City of Phoenix PLANNING AND DEVELOPMENT DEPARTMENT

Staff Report Z-40-19-7 August 30, 2019

Proposed Use: Multifamily residential

Location: Approximately 360 feet east of the northeast corner of 2nd Street and Roeser Road

Figure C. Proposed Site Plan

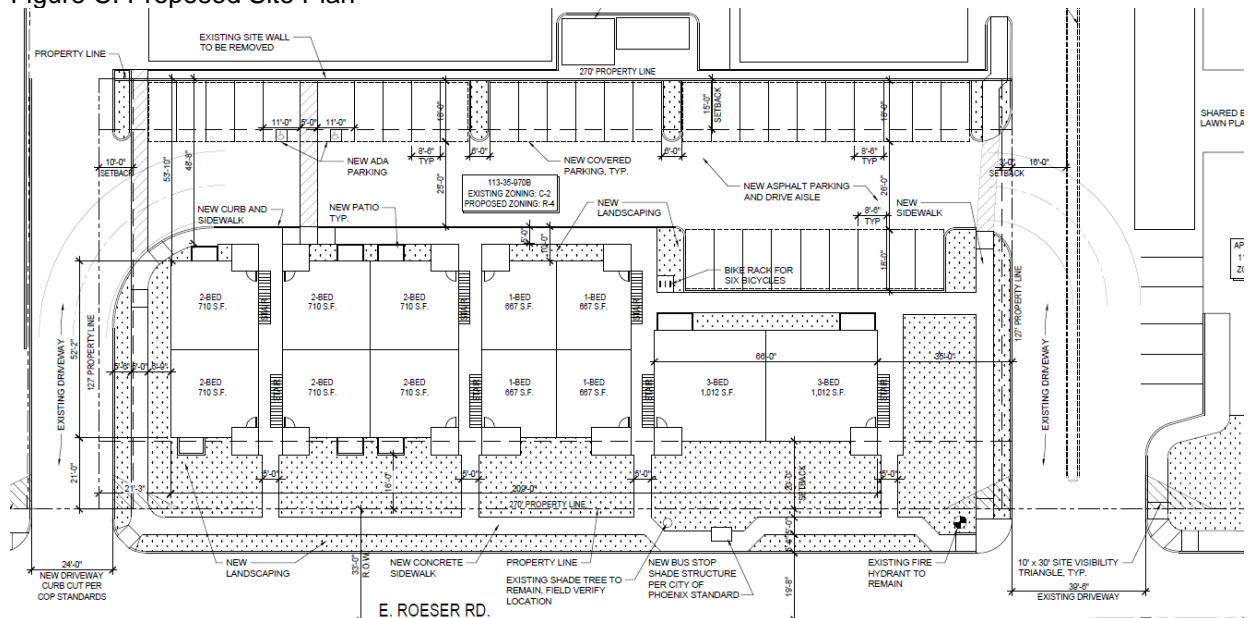
If combined with the adjacent development as planned, the site plan would be generally compliant with code; however, as a stand-alone development, the following deficiencies exist:

- A minimum five-foot landscape setback would be required along the north property line. There is no landscape setback proposed.
- A minimum 5 percent common open space is required for all multifamily projects in the City of Phoenix. There are no open spaces provided on the site, however, the larger apartment complex appears to include sufficient open space.

- A minimum of 2 resident amenities are required for all multifamily projects in the City of Phoenix. There are no resident amenities provided on the site, however, the larger apartment complex includes sufficient amenities.

Additionally, the parking supply is deficient by four parking spaces. While the development is situated in close proximity to a proposed light rail station, it is currently ineligible for the 25 percent parking reduction cited in the development standards table.

Figure E. Proposed Elevations (Top, Roeser Road Frontage) (Bottom, North Elevation)

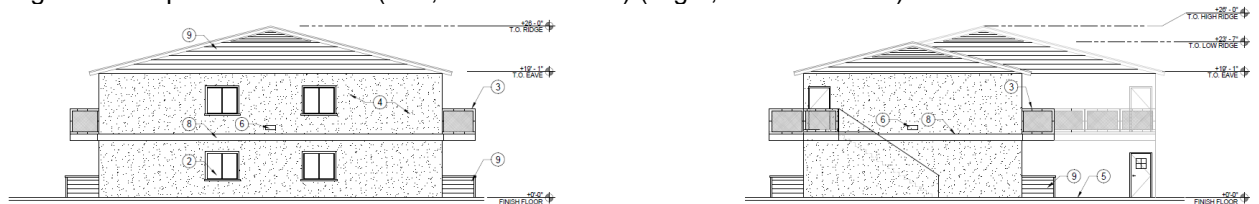
The conceptual site plan calls for a segmented two-story multifamily building. The conceptual elevations include patios, balconies, contrasting trim, and undulating rooflines which run a maximum width (east-west) distance of 62 feet. The architectural enhancements are intended to make the building more approachable and pedestrian-oriented.

1. All building facades shall contain architectural embellishments and detailing such as textural changes, pilasters, offsets, recesses, window fenestration, shadow boxes and/or overhead canopies at least every 50 linear feet, as approved by the Planning and Development Department.

5. All individual units above the ground floor shall have a shaded balcony of no less than 50 square feet in total size with a minimum depth of five feet, as approved by the Planning and Development Department.
